From: John Gray, PINS ID number [REDACTED], PINS Case Reference: EN010162  
To: Planning Inspectorate  
Date: 10 December 2025  
Subject: Recreation Changes in Bathley and North Muskham  
(Community Orchard, Permissive Footpath 3)

I write to ask that ExA consideration is given to issues arising from the two proposals labelled in Figure 1 Annotated extract of map from Elements Green's [APP-190,p.8] below.

Figure 1 Annotated extract of map from Elements Green's [APP-190,p.8]

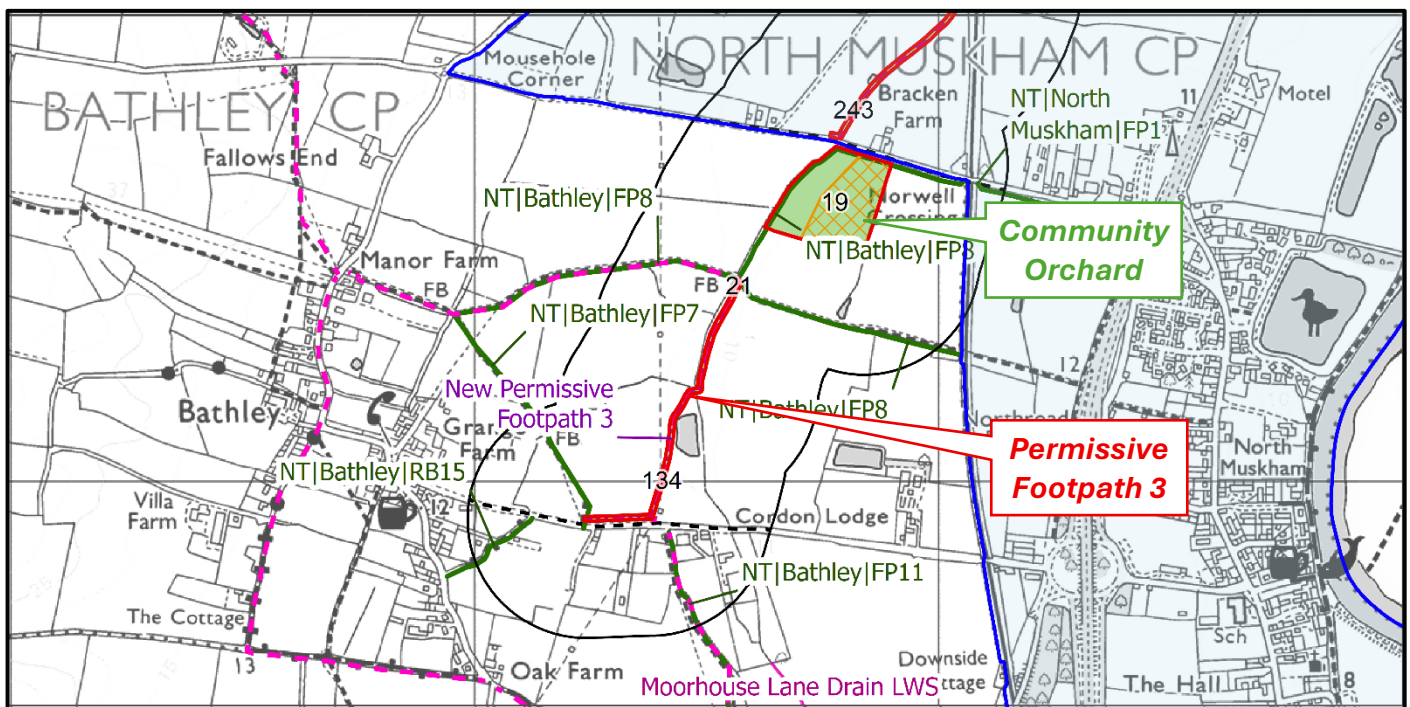
***I support both of the proposals in principle but wish to:-***

- ***Suggest the need for clarification of aspects of the Community Orchard proposal.***
- ***Request a small-scale realignment of the proposed route of Permissive Footpath 3.***

Figure 2 Best available 'plan' of the proposed orchard, from [APP-040,p.8] with annotations

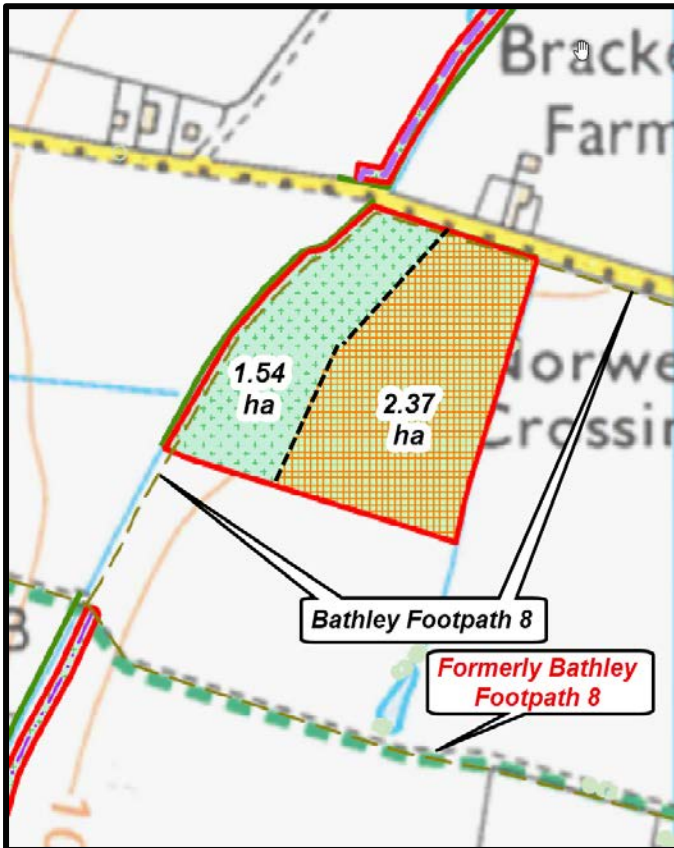
Figure 2 below is the most detailed 'plan' of the orchard I have been able to find in the APP documents [this level of detail occurs in many maps, I've taken this from APP-040,p.8], and added to it internal subdivisions and areas in the OL boundary.

- i. Is there a full plan and design document, with detailed proposals, in existence? If not, when will there be one available?
- ii. The applicant says *"The orchard is accessible via PRow."* [APP-061,p.46]. Where do the actual boundaries of the Community Orchard lie? The current route of Bathley Footpath 8 [NCC Footpath Modification] is shown as within the Order Limit, but is it considered as within the Community Orchard boundary? If so, will there be fences/stiles controlling public access? Or even *"gated and closed at night"* as talked of in Maplebeck [APP-061,p.17]?
- iii. Who owns the Community Orchard and the land it is to be developed on? Which organisation/business is expected to manage the orchard on a day-to-day basis, during construction and thereafter?

- ii. One of the design objectives included in [APP-201,p.5] is *"Creation of Community Orchards to engage and promote community involvement"* and [APP-313,p.39] claims that during consultation *"Respondents support the creation of the proposed community orchard/picnic areas."* but I can find no specific reference in the Consultation Report [APP-296] to the community orchard. Is there data to indicate this support will translate into involvement?

Figure 3 Map & Google Earth Photo of Suggested Realignment of PF3

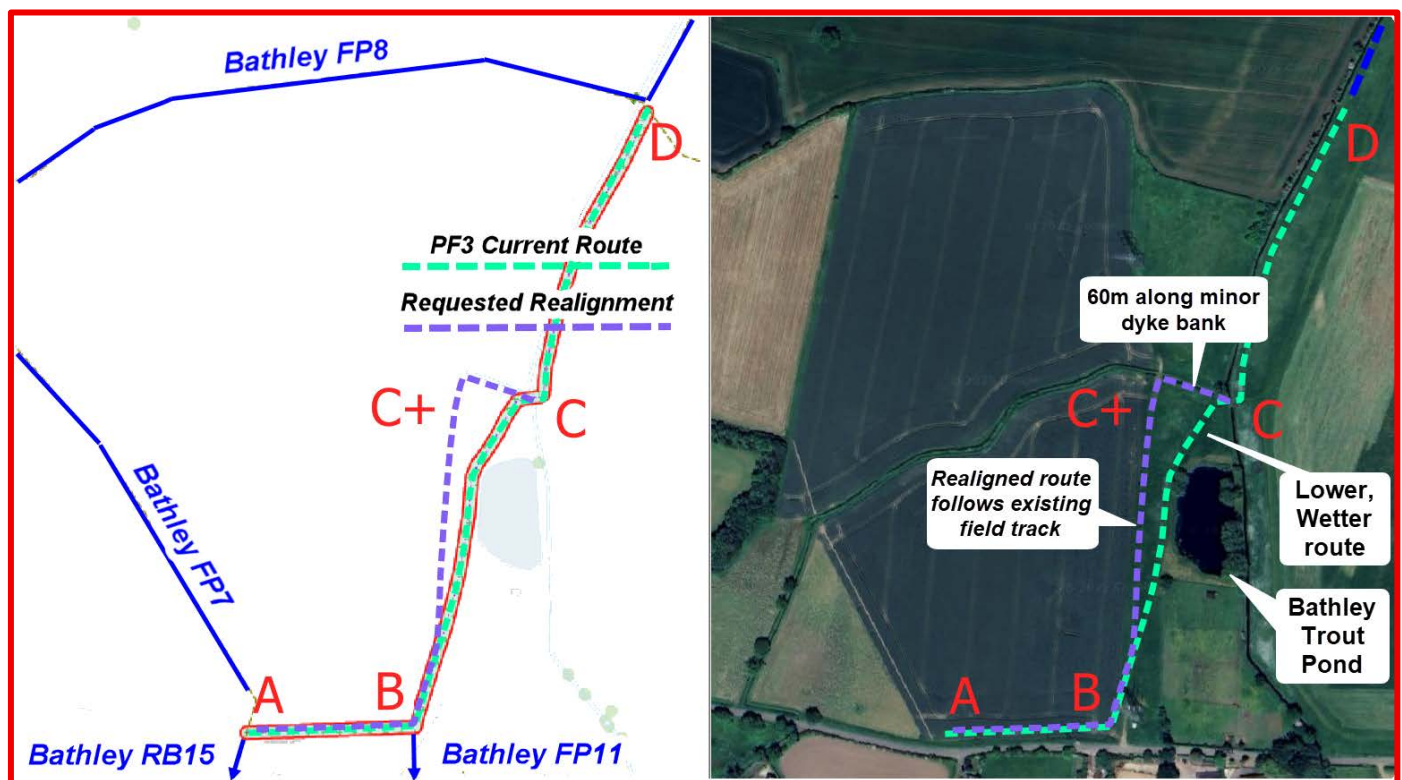
- PF 3 will pass very close to Bathley Trout Pond, which is a registered fishery (DEFRA and CEFAS). The pond is a site of active wildlife protection, including a baited mink raft licensed by the Water Life Recovery Trust, which targets American mink to protect water voles.
- Bird feeders support a variety of birds such as ducks, geese, swans, pheasants, partridge, songbirds, water hens, and coots. The pond is used by kingfishers, swallows, and house martins during breeding season, and these species could be disturbed by increased foot traffic.
- Fly-fishing (catch and release) occurs at the pond, and the activity could pose a safety risk to walkers due to the danger of back casts. The pond is deep (10–18 feet), presenting a safety hazard. There is concern that dogs could enter the pond, disturbing wildlife and risking their own safety.

Realigning the currently proposed PF3 route between B and C via point C+ would provide a minimum separation of 25m between PF3 and the pond; use an established (and dry) field track B-C+, and then follow a 60m new path along the southern edge of a minor dyke to rejoin the route at C.

***On the basis of several recent discussions with the resident I am persuaded that this realignment of Permissive Footpath 3 would protect the resident's conservation activities (and actually improve the route by avoiding the frequently very wet area immediately N of the pond).***
